TECHNICAL BULLETIN

Hood Panel – Difficult To Latch – Revised Latch and Hood Release Lever Guard Introduced – Service Action S448

76-96

MODEL XJS Range 1994 - 1995 MY DATE 11/94

ILLUSTRATION 1

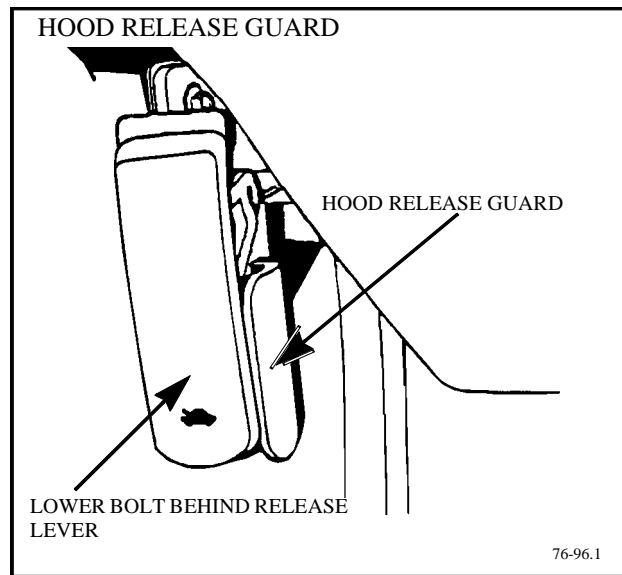
To prevent inadvertent operation of the hood release, a release lever guard was introduced in production at VIN 194776.

1. Remove the lower bolt of the hood release lever.
2. Align the guard as shown in Illustration 1 and replace the lower bolt.

ILLUSTRATION 3

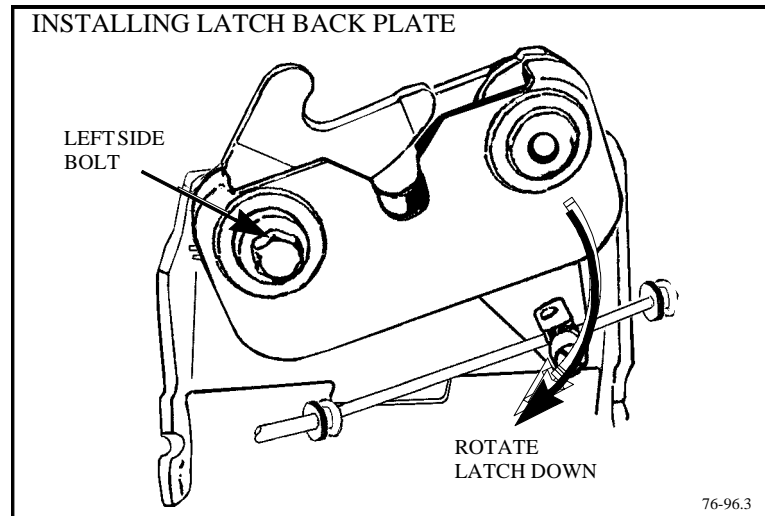
The revised latch back plate accomplishes the following:

- Prevents the latch pawl from going over center
- Increases the pawl return spring pressure to aid hood “pop-up” when the hood is released.

4. Place the new latch back plate behind the latch in the position shown in Illustration 3. Insert the left side bolt through the back plate to use as a pivot.
5. Rotate the right side of the latch down to “wind up” the latch spring and insert the right side bolt.
